### REMARKS

The Office action of February 27, 2004, has been carefully considered.

Fig. 6

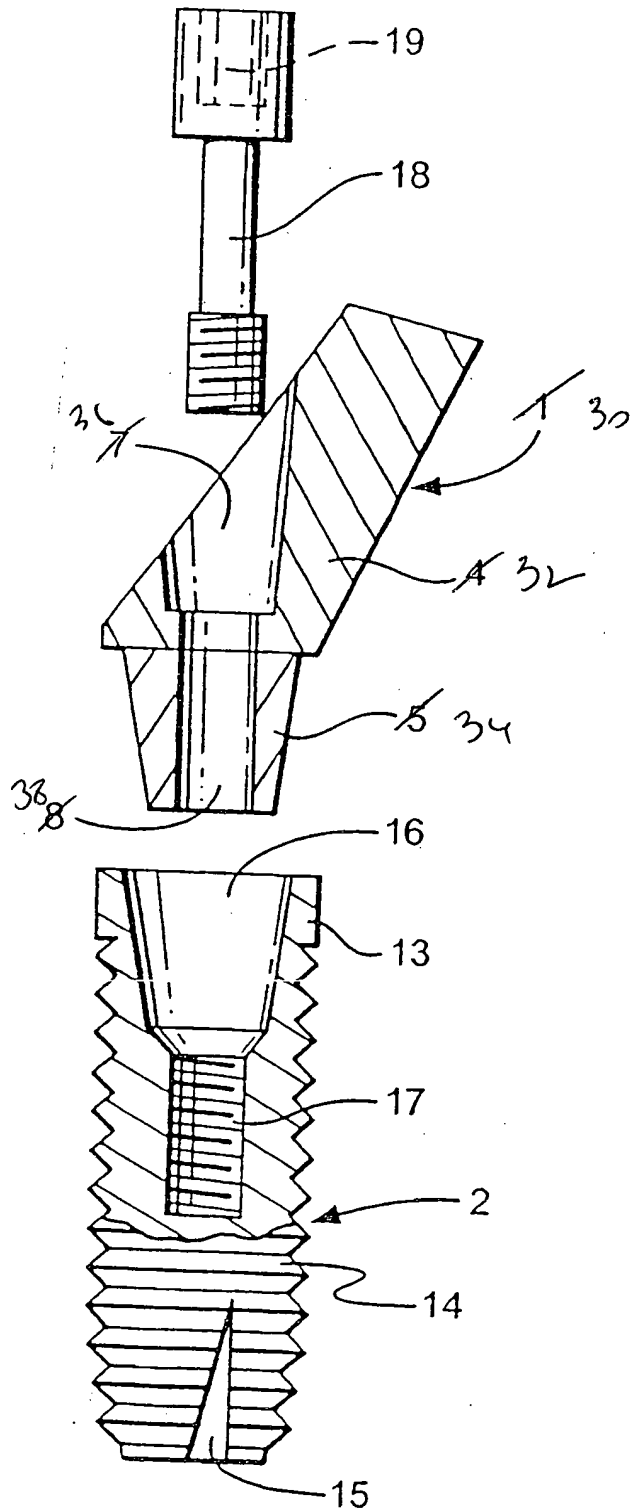
Moreover, Applicants have also noted that Figures 6 and 8 are directed to abutments rather than templates, especially given the presence of bolt 18 which locks the abutment onto the implant. Applicants have therefore renumbered Figures 6 and 8 in accordance with the abutment as shown in Figure 2, and amended the specification in accordance with this new numbering. Applicants believe that these changes do not constitute new matter because one of ordinary skill in the art would understand that Figure 6 and 8 relate to abutments rather than templates.
